Docket Item # 2
BAR CASE # 2008-0242

BAR Meeting
February 4, 2009

ISSUE: Alterations
APPLICANT: Virginia Magestic for Bob and Rebecca Sutton
LOCATION: 713 South Pitt Street
ZONE: RM/Residential

Figure 11: Rear portico elevations and specifications submitted for 2/4/2009 OHAD Hearing.

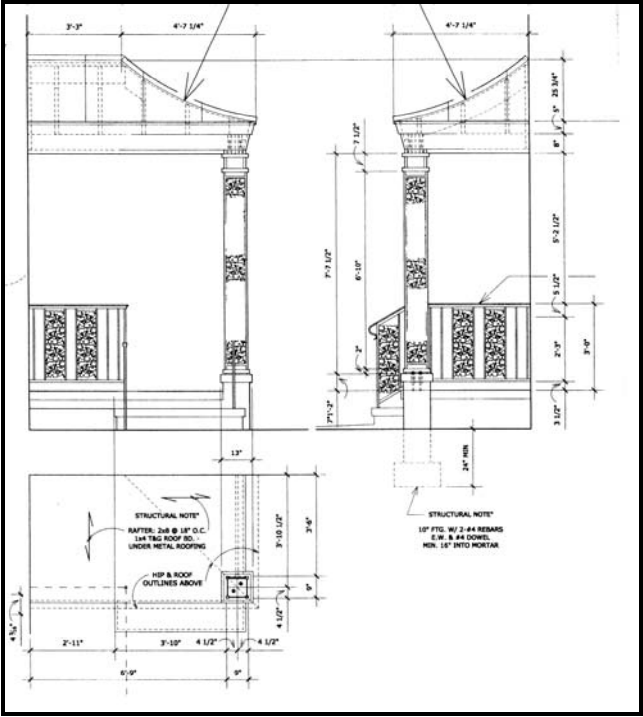
The rear portico will have a flared copper roof and will be installed over the existing stoop. The roof will measure 7' 10 ¼" wide and will project 4' 7 ¼" from the building façade. The same decorative square columns supporting the roof are proposed for the rear elevation.

Staff does not object to the style of the proposed front portico because 713 South Pitt Street, as well as many of the townhouses in the Yates Garden development, does not reflect one specific architectural style. However, Staff does object to the use of Azek (plastic) trim on the porticos. The *Design Guidelines* recommend that porches (and porticos), railings and stoops be constructed of materials which are sympathetic to the building materials generally found in the historic districts. In the opinion of Staff, the trim on porticos should be constructed of wood.

1. That the open iron columns are two sided and not four sided;
2. That the floral pattern encompass the entire height and both sides of the two sided column; and,
3. That the trim on the porticos be constructed of wood and not Azek.

Figure 13: Front portico elevations and specifications submitted for 2/4/2009 OHAD Hearing.

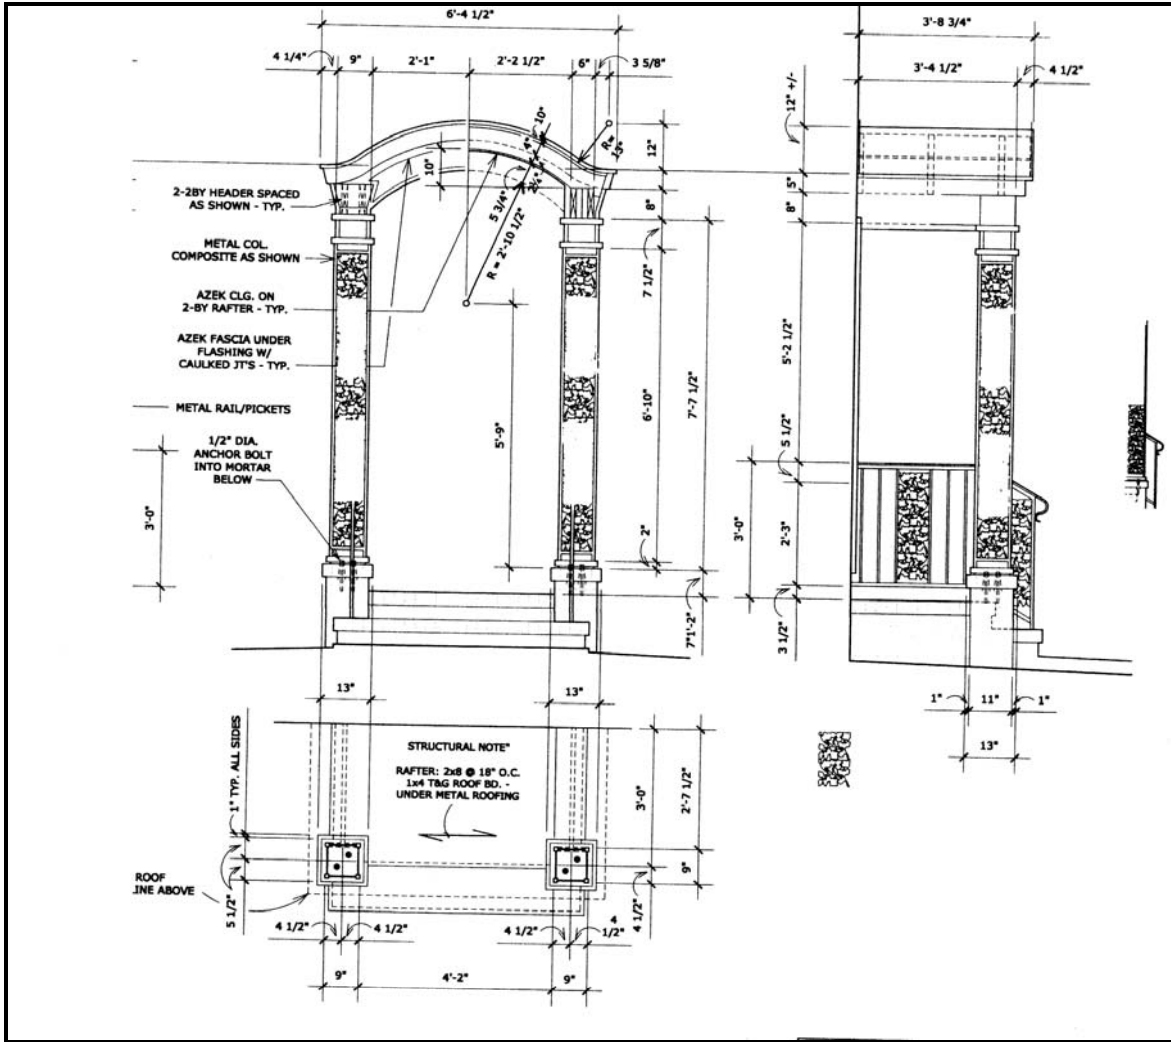
The applicant proposes to install a new portico with decorative open iron columns over the existing front stoop. The proposed new arched roof portico will measure 6' 4 ½" wide and will project 3' 8 ¾" from the front building wall. The roof of the portico will be clad with standing seam copper. The existing shutters on either side of the front door will be removed and the existing light fixture above the front entrance will be relocated to the south side of the door. The decorative columns will be constructed of open ironwork and will measure 9" on each side. The columns will have the same floral pattern as the existing railing ironwork but in three sections on the vertical column – at the top, in the middle and at the base.
